# ADMINISTRATIVE REPORT

**Title:** DAV 25-197637\C – 951 Portage Ave

**Issue:** For variances to enable the construction of a mixed use commercial and multi-family building.

951 PORTAGE AVENUE  
MIXED-USE DEVELOPMENT

5 WINDOW ELEVATIONS  
Scale: 1/4" = 1'-0"

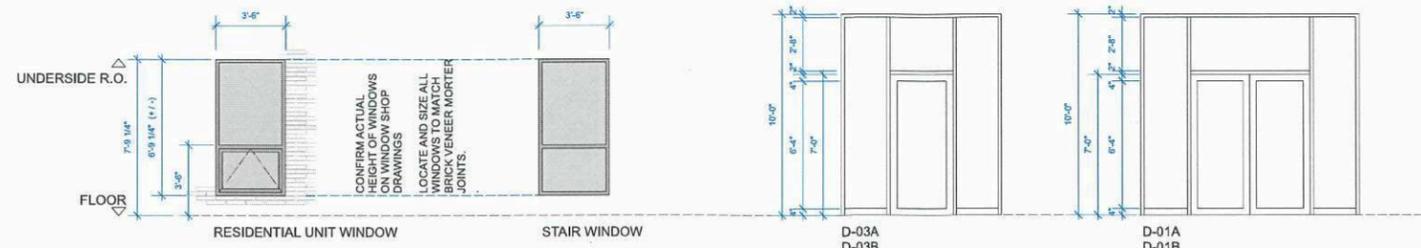
- The Malls and Corridors Planned Development Overlay requires exterior window treatment to prevent bird collisions. The applicant has not proposed any window treatments on their windows. For this reason, a variance is required.

- In correspondence with the Public Service, the applicant indicated sourcing the correct windows to comply with the by-law is difficult. The Public Service acknowledged that a suitable alternative could be accepted. Therefore, a condition on this approval has been included requiring an alternative bird friendly window treatment be submitted to the Director of Planning, Property and Development. For this reason, the variance is supportable.

No window treatment was provided with the submitted plans, necessitating a variance. To address this, a condition has been included requiring a suitable bird friendly window treatment be submitted to the Director of Planning, Property and Development prior to the issuance of a development permit.

1. That, if any variance granted by this order is not established within two (2) years of the date hereof, this order, in respect of that Variance shall terminate.
2. That, prior to the issuance of development permits, the owner must submit plans showing the location and design of a suitable window treatment (visual marker) consistent with bird-friendly window design on the Owner's Land ("Works") to the Director of Planning, Property and Development and thereafter must construct the Works in substantial conformance with the window treatment and maintain the Works to the satisfaction of the Director.
